# **BCA Performance Solution**

Freshwater Surf Life Saving Club Kooloora Avenue, Freshwater NSW

Alterations and Additions to mezzanine / Level 3

Ref - 20094 - R1.0

Figure 1 – Mezzanine floor plan illustrating minor new club office (40m²) in white (existing building shaded yellow)

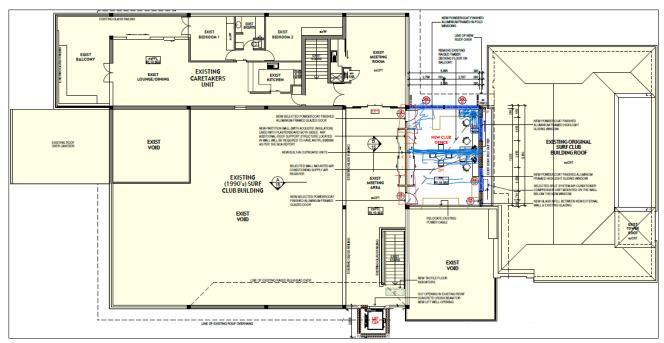
Nil passenger lift is proposed. This causes a compliance departure with BCA Clause D3.1.

See Figure 1 for compliance departure illustration.

Meeting room is leased to public

Disagree
- viii. Staff will be present at all times of business operation and are able to assist / manage visitors.
- ix. All building functions are primarily available on the ground (main) level); hence, a visitor can carry out all required functions on the accessible (main) level, without need to access Level 3. The Level 3 office / meeting spaces are extra-over to what is available at the ground / main level of the building.

This does definitely not constitute unjustifiable hardship

No loss of floor space would occur

PS. No.	Requirements		
PS1	The stairway leading to the mezzanine / Level 3 must be upgraded with access features to accord with Clause 11 & 12 of AS 1428.1-2009.		
	i.e. 2x handrails, handrail extensions, tactiles & stair nosings.
